Comments on the Environmental Impact Assessment (EIA) and Appropriate Assessment (AA) in relation to PA/06096/23 (EA/00020/22)

PROPOSED THERMAL TREATMENT FACILITY IN THE ECOHIVE COMPLEX, INCLUDING PLANT BUILDING, STORAGE BUILDING, ADMINISTRATION BUILDING, WASTE WATER TREATMENT, TANK FARM AND CISTERNS

SITE AT, ECOHIVE COMPLEX, TUL IL-KOSTA, NAXXAR

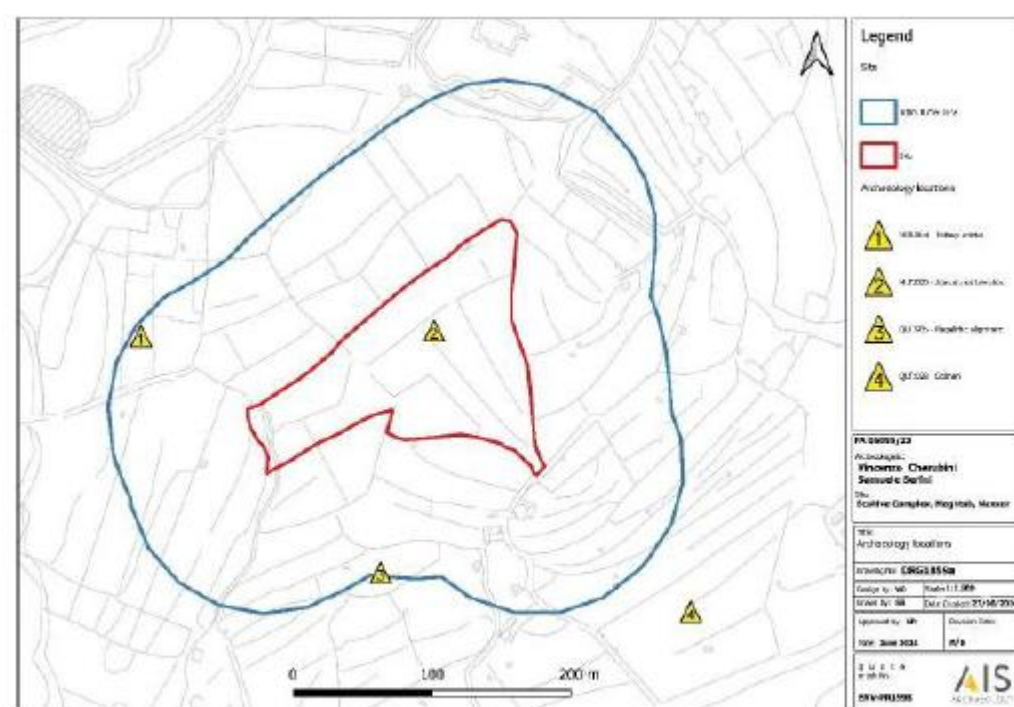
The Superintendence notes that the study includes a section on cultural heritage. This section does not make reference to the cultural heritage features in close proximity to the development provided by the Superintendence at TOR stage.
